NAC Storage Transport Cask

WVDP Vitrified Waste
and High Burnup Fuel
Amendment Application

RAI Response Package

Docket No. 71-9235

Figure 7.3-1 Cask Cooldown Piping and Controls Schematic

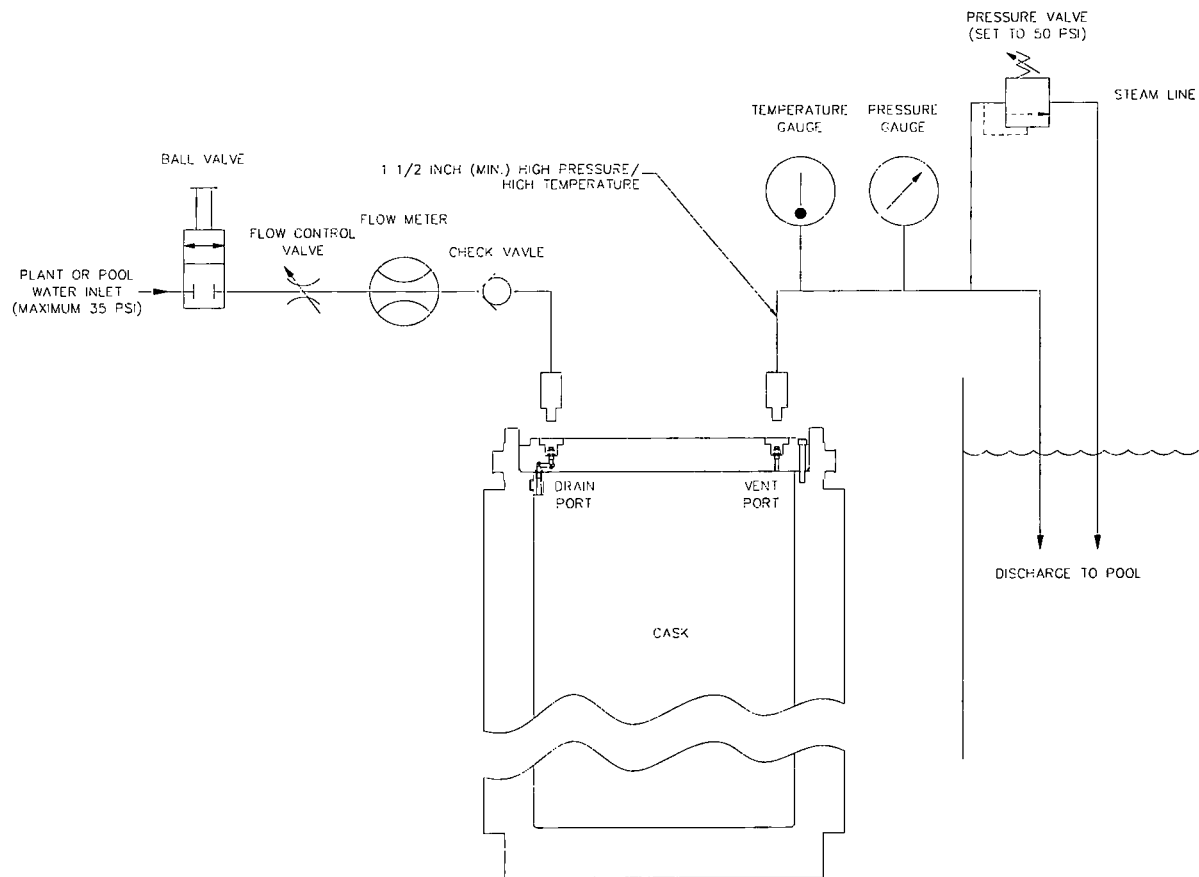
- Co-7-4. Provide Section 7.4, "Leak Test Requirements," and Figure 7.3-1, "Cask Cooldown Piping and Controls Schematic," of the application.

The staff needs to ensure that Sections 7.4, "Leak Test Requirements," 7.4.1, "Containment System Verification Leak Test Procedures," and 7.4.2, "Leak Testing for Transport After Long-Term Storage," have not been removed from the application. Because Figure 7.3-1 of the application was not provided in the most recent revisions to the NAC-STC safety analysis report, and it is adjacent to Section 7.4 of the application, it is not clear if Figure 7.3-1 of the application is still part of the application. The staff also needs to ensure Figure 7.3-1 has not been removed from the application.

Figure 7.3-1 and SAR Sections 7.4, 7.4.1, and 7.4.2 were unchanged in the original application. As Sections 7.4, 7.4.1, 7.4.2, 7.4.3 and 7.4.4 have now been revised in response to the current RAIs, these sections are included in the revised SAR pages submitted with the RAI responses. Figure 7.3-1 was not revised so this page was not submitted with the application as this page was not a changed SAR page. As noted, the consolidated SAR, Revision 17, contains this information, as it is the latest approved SAR revision. Upon approval of the application, the SAR changed pages will be consolidated and incorporated into SAR Revision 18.
